Reference: Beaver Valley Power Station, Unit No. 1
Docket No. 50-334, License No. DPR-66
IE Bulletin 80-11

This letter forwards the additional information for IE Bulletin 80-11, "Masonry Wall Design" as requested by your letter dated March 23, 1982.

Beaver Valley Power Station - Unit 1

The following is provided as the response to the NRC request for additional information dated March 23, 1982. This report provides a reprint of each of the seven (7) staff questions with the applicable response following the question.

DUQUESNE LIGHT COMPANY ENGINEERING & CONSTRUCTION PITTSBURGH, PA.		I&E BULLETIN 80-11, BLOCK WALL PLANS AUXILIARY BUILDING EL 735'-6"	
SCALE: 1/8" = 1'-0" DRAWN: E.L.C. LHM CHECKED: H.E.L. LHM PROJECT: E.T.C. LHM		BEAVER VALLEY POWER STATION UNIT NO. 1 D.P.E. NO. AA No. 8700-R C.O. NO.

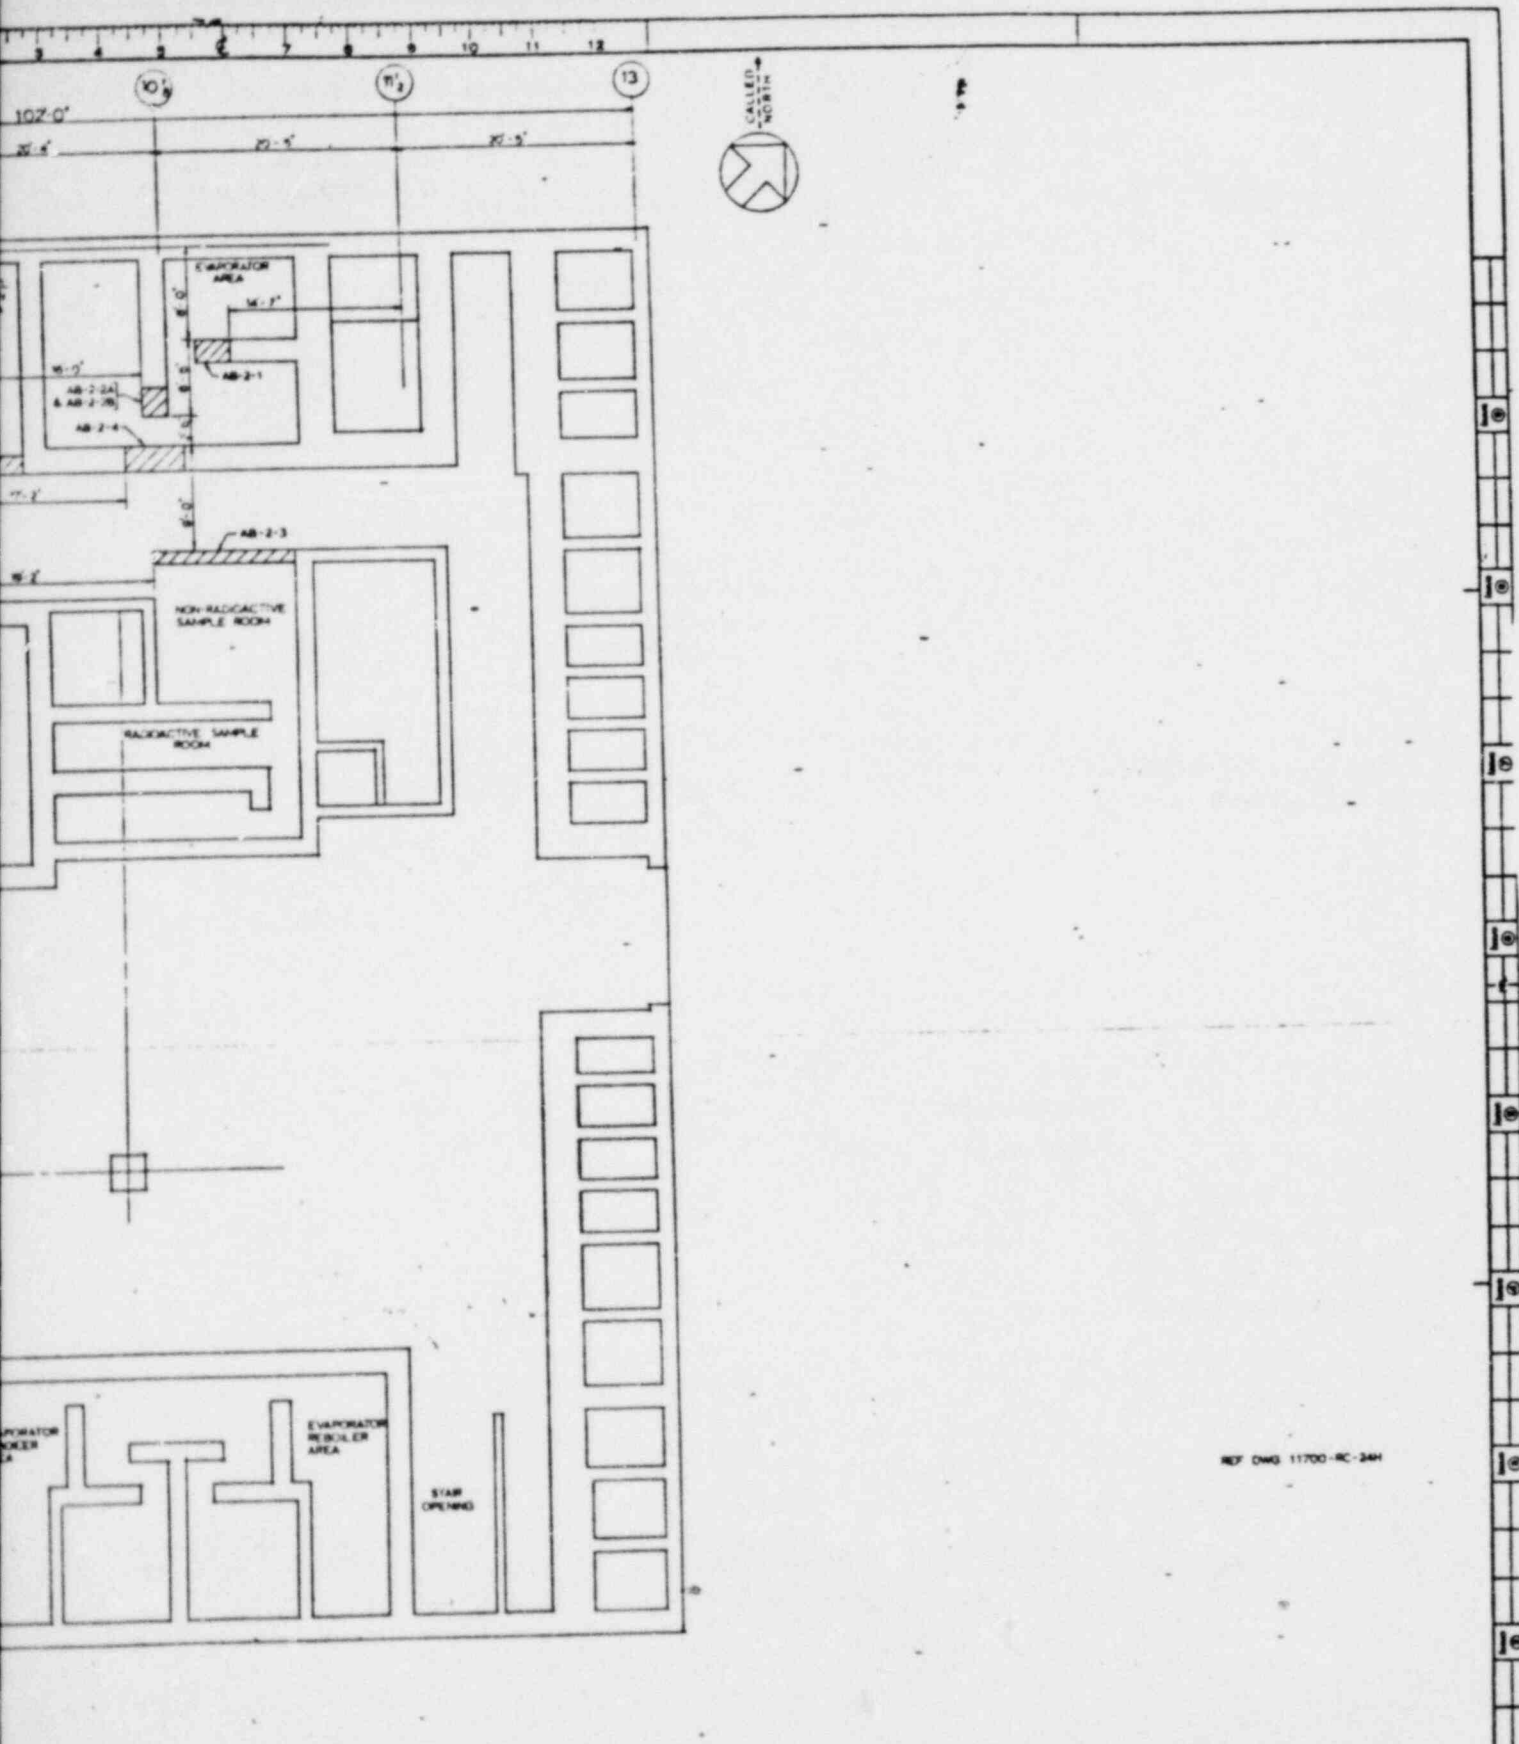
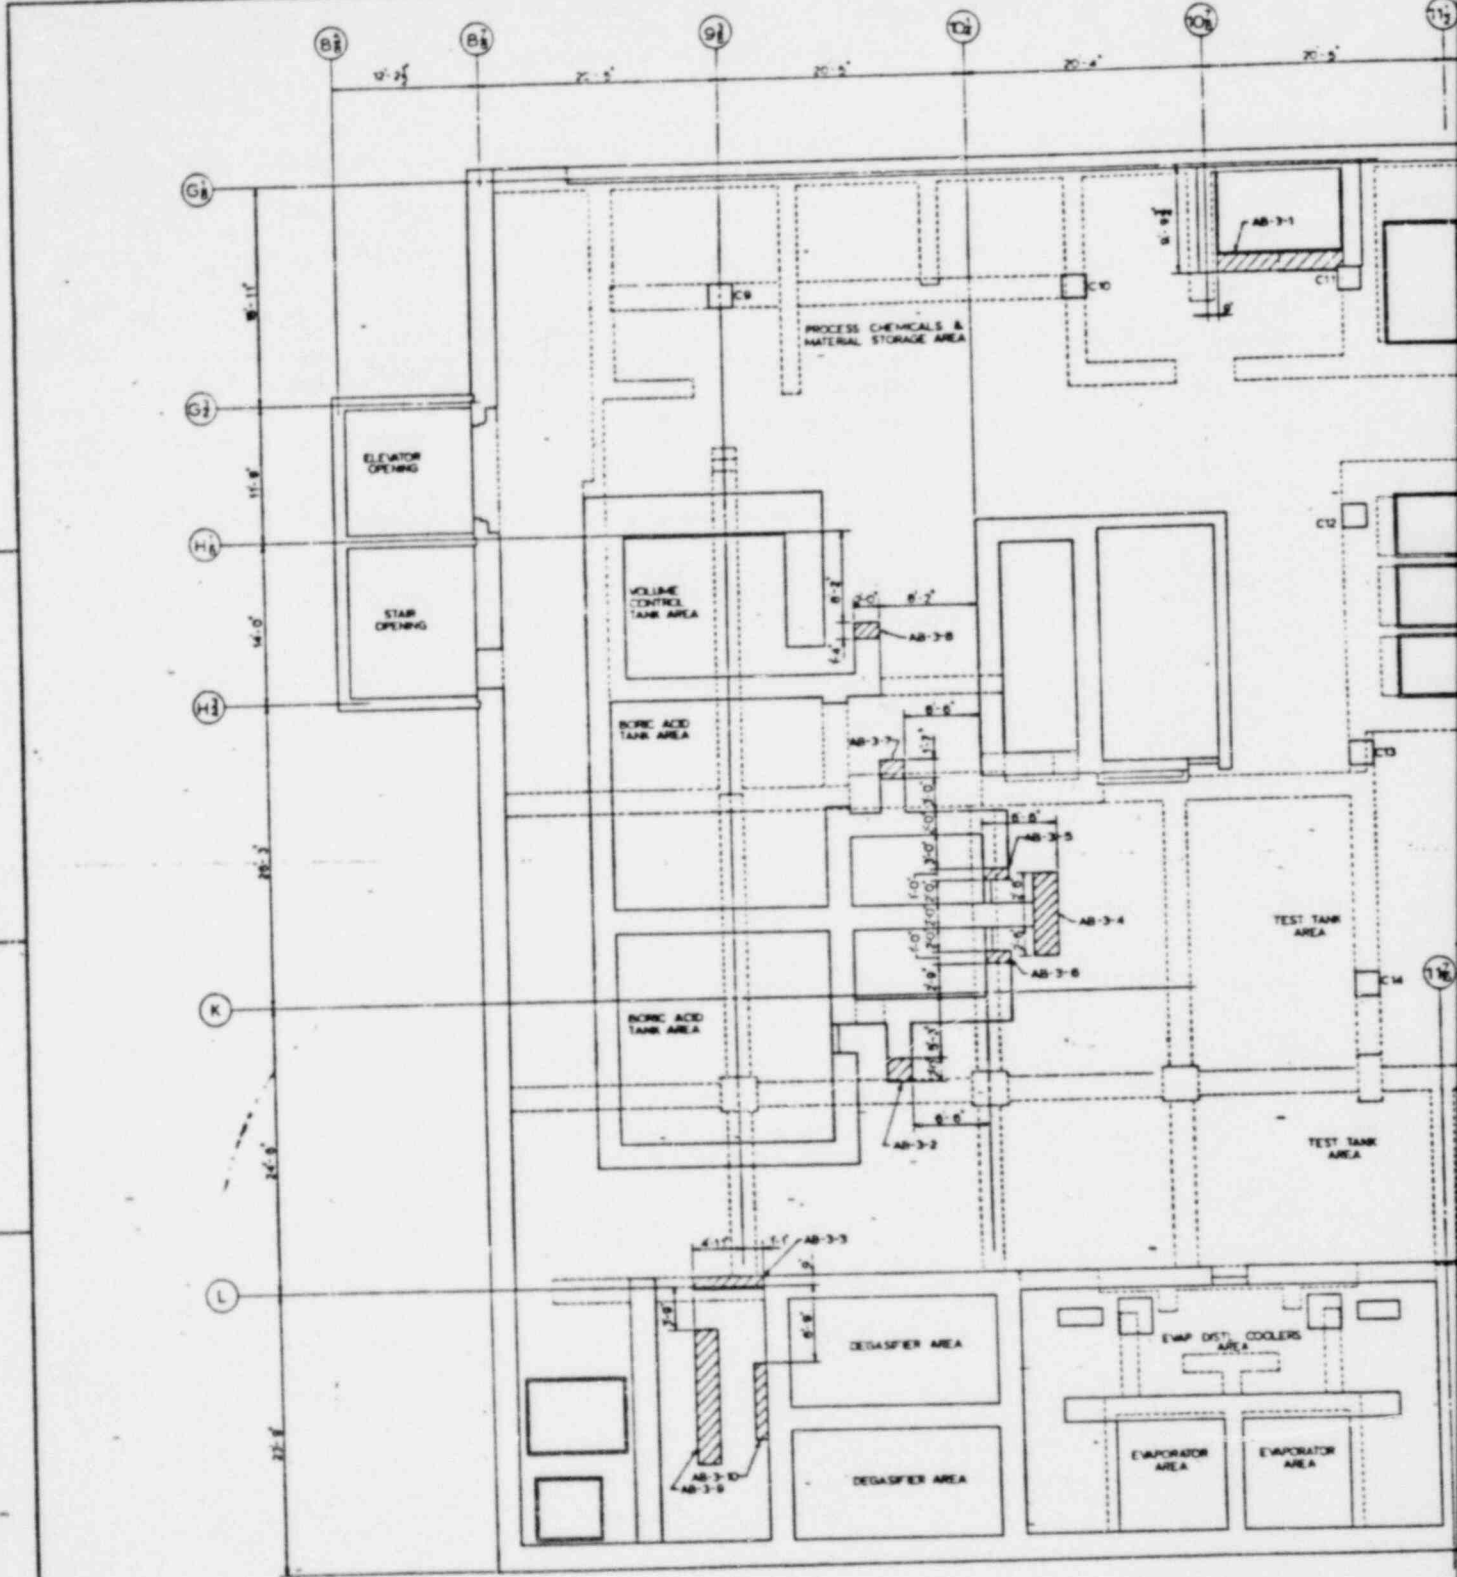
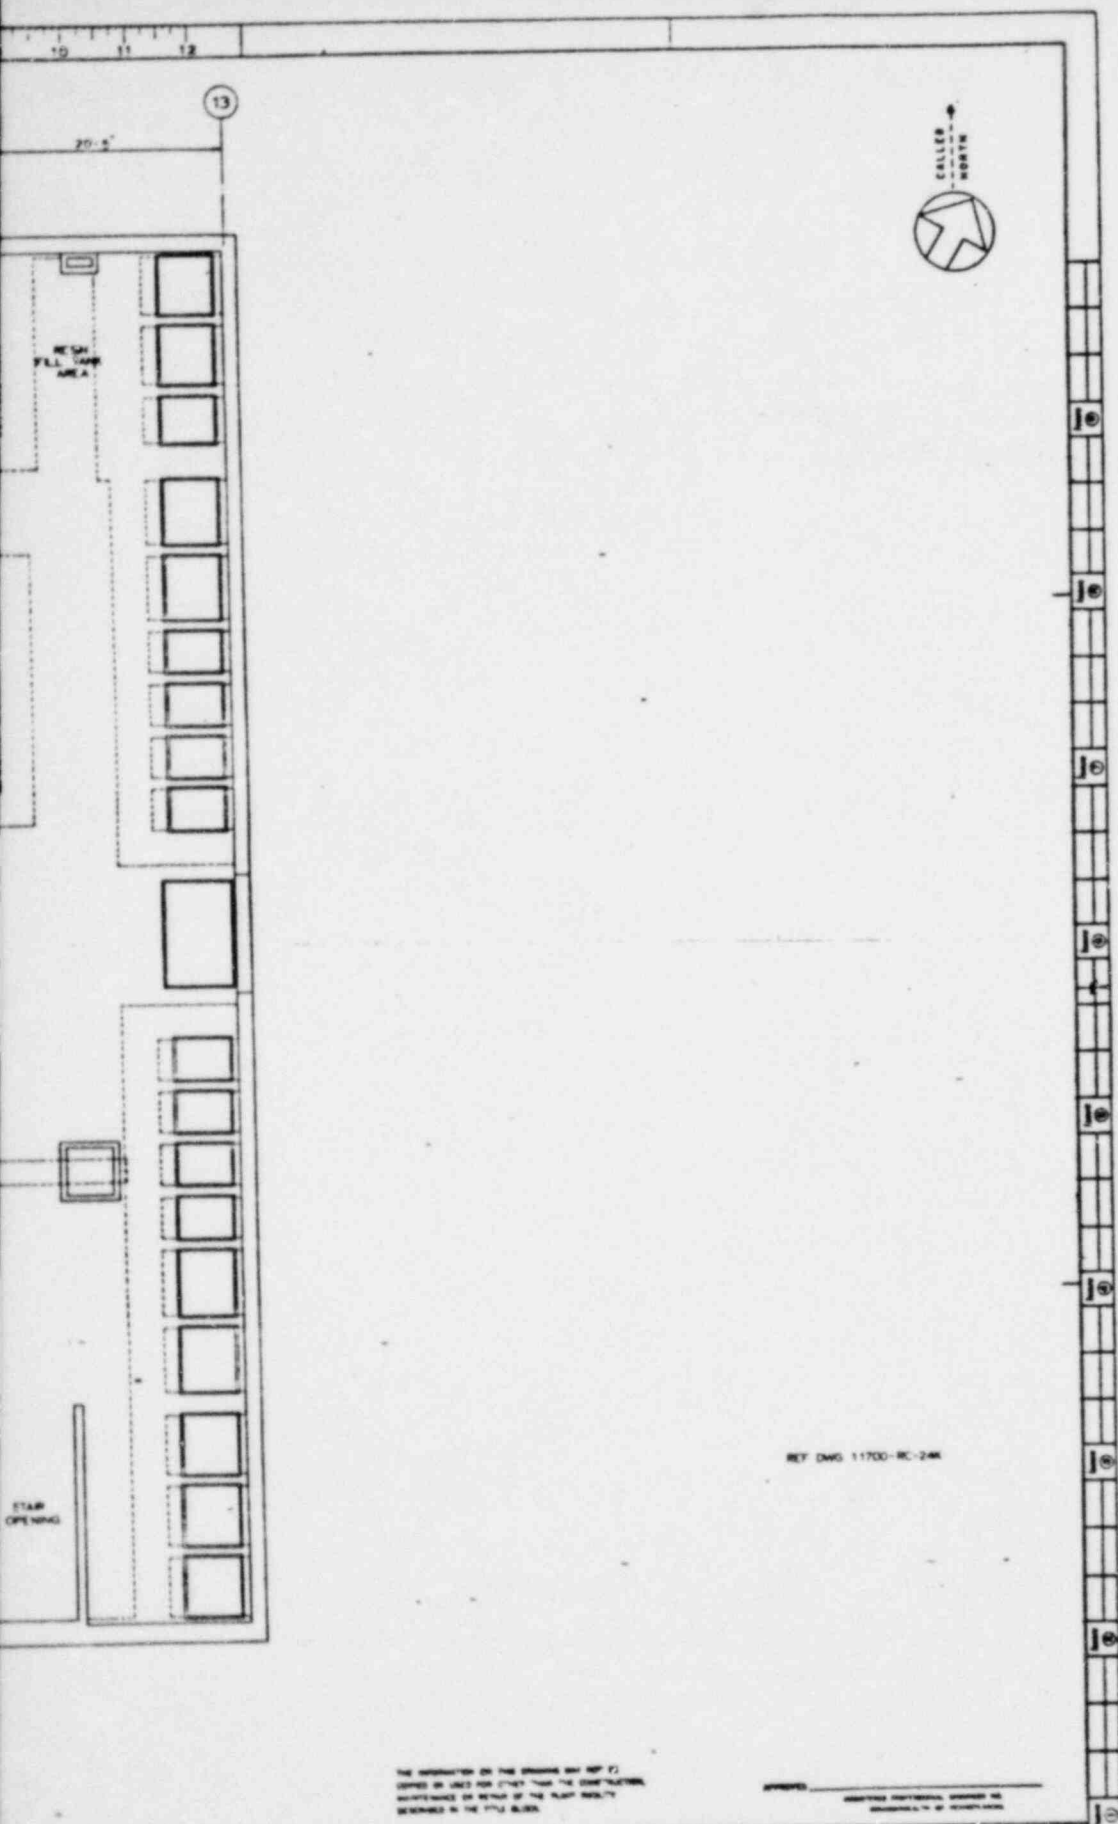
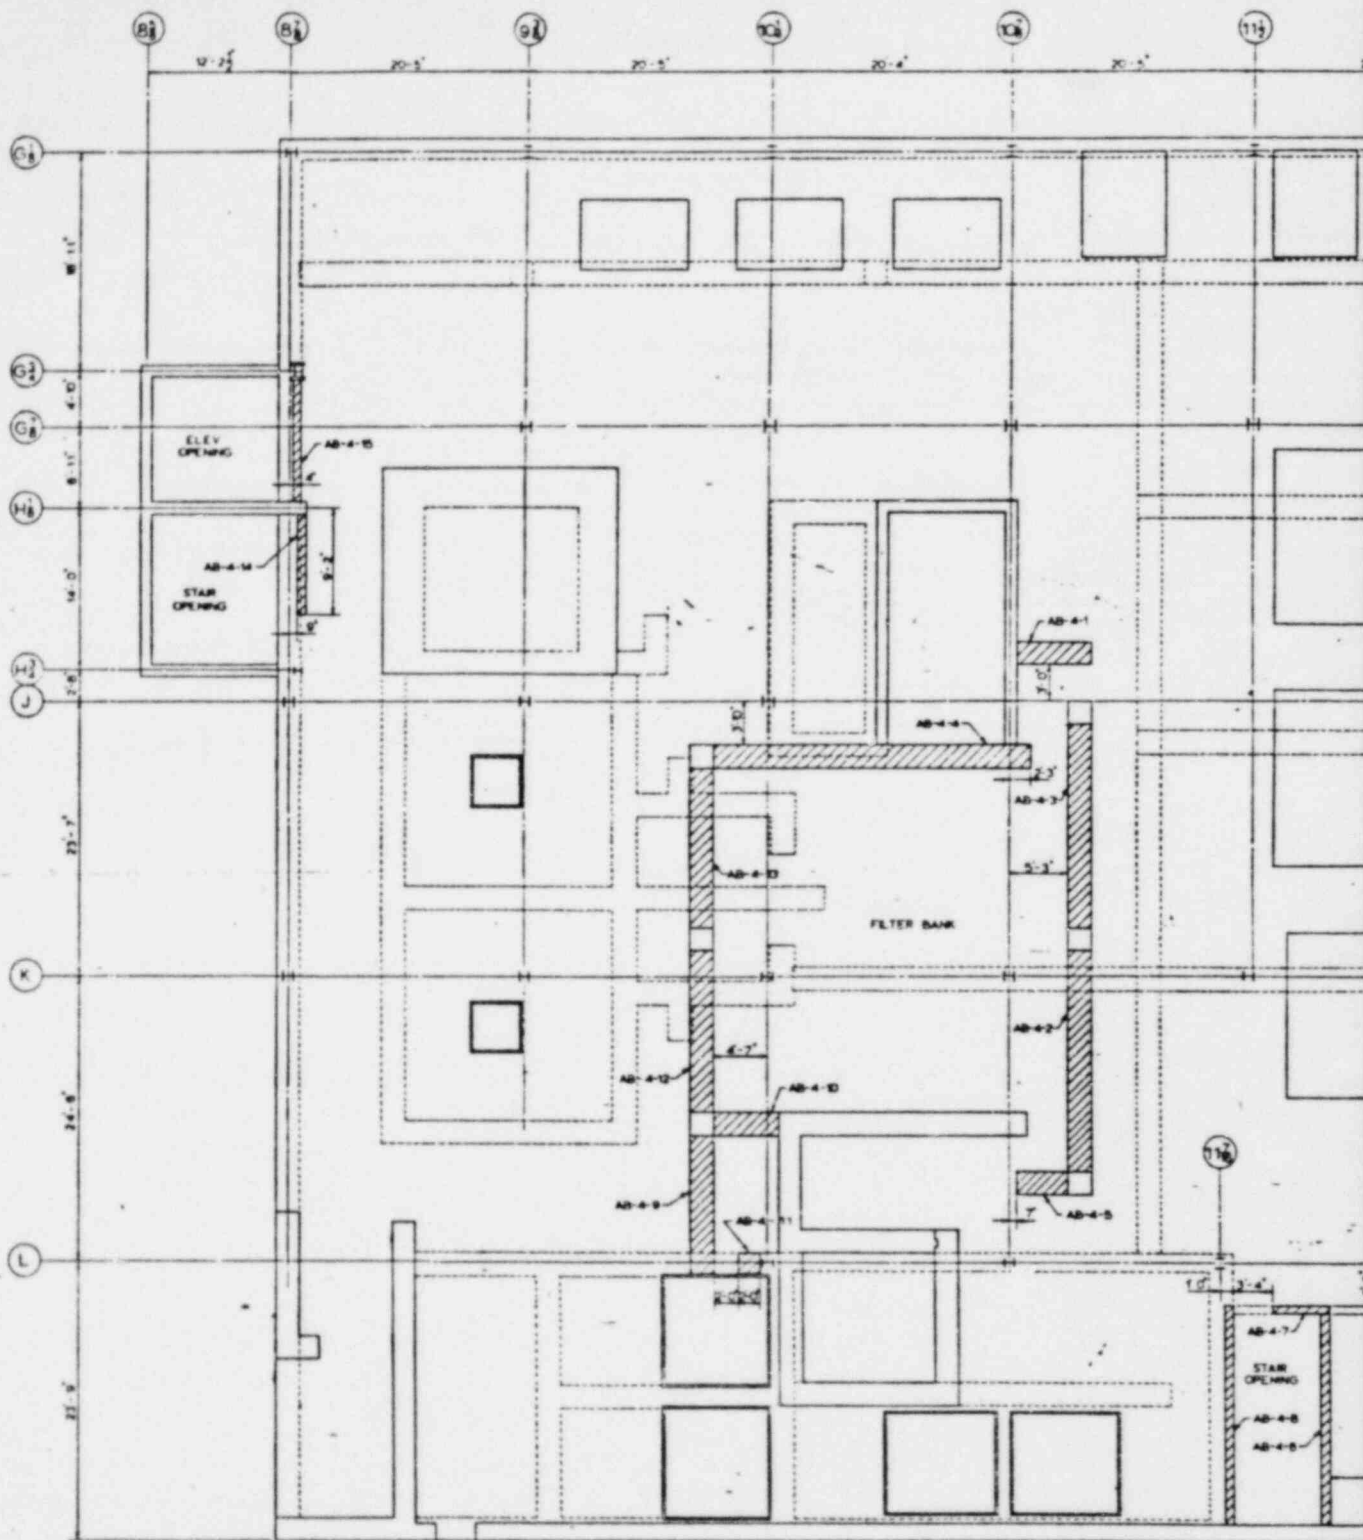
6. Provide legible copies of drawings indicating the locations of safety-related masonry walls in the auxiliary building, cable vault, fuel and decontamination building, and service building of Beaver Valley Power Station Unit 1. Location plans for auxiliary building masonry walls included in Attachment A of Reference 3 are not legible.
